STAFF REPORT: 4/12/2022
PREPARED BY: T. BOSCARINO
REVISED ON APRIL 12, 2023 (revisions shown in bold red type)

APPLICATION NUMBER: 23-8283
ADDRESS: 3509 AND 3521 SEMINOLE
HISTORIC DISTRICT: INDIAN VILLAGE
APPLICANT: JACOB M. LUBIG, VENTURE DESIGN
PROPERTY OWNER: HENDERSON, MARSHA & SONUYI, TOLULOPE
DATE OF PROVISIONALLY COMPLETE APPLICATION: 3/14/2022
DATE OF STAFF SITE VISIT: 3/23/2022

SCOPE: CONSTRUCT PERGOLA AND PATIO, REMOVE WINDOWS AND INSTALL SLIDING DOOR

Rendering of the proposed work as viewed from the Seminole (east and front) side of the property. Image from application documents.

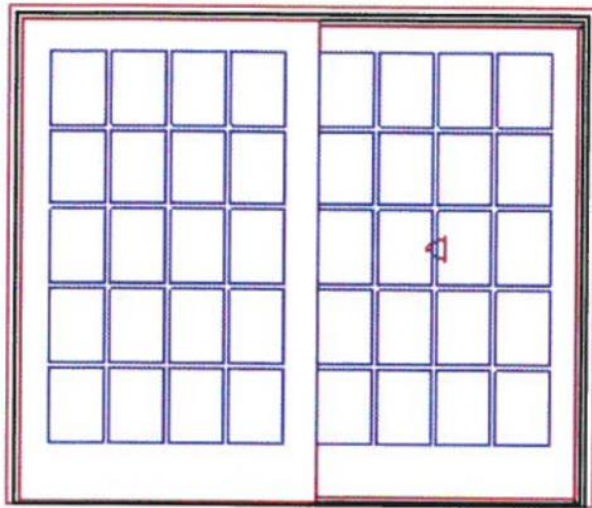
The pergola is to be 12’2” tall, composed of treated lumber wrapped in pine or cedar. A paint color or finish is not specified, though a light green similar to the trim color of the house is shown in renderings. The proposed pergola features recessed downlighting.

- Staff opinion is that the bay of windows and the shed roof overhang proposed for removal are not distinctive, character-defining features.
 - The landscaped open space of the side lot is a character-defining feature, as noted in the Elements of Design (quoted above). However, the proposed pergola and patio area, due to its modest scale, does not overwhelm or destroy the feature; neither does it change the relationship of the house to its side lot.

- Some details regarding exterior finishes are lacking from the application.
 - ~~The proposed door has a “stone white clad exterior,” but the material of the cladding is not specified.~~
 - ~~The proposed door has “7/8” SDL” (simulated divided lites) but the thickness, material, and location (within, behind, or in front of the glass) are not specified.~~
 - The finish of the proposed pergola is not specified.

- The finish of the pergola shall be subject to approval by staff.

Proposed new door. Images from application documents.

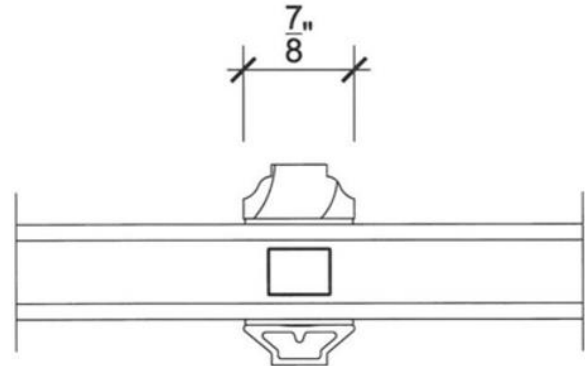
The proposed door is a sliding, aluminum-clad wood door in “stone white” color. It has “7/8’ SDL” (simulated divided lites) with false muntins on the interior and exterior and spacers between the glass panes, closely approximating a true multilight door.

- ~~The door shall be subject to approval by staff.~~
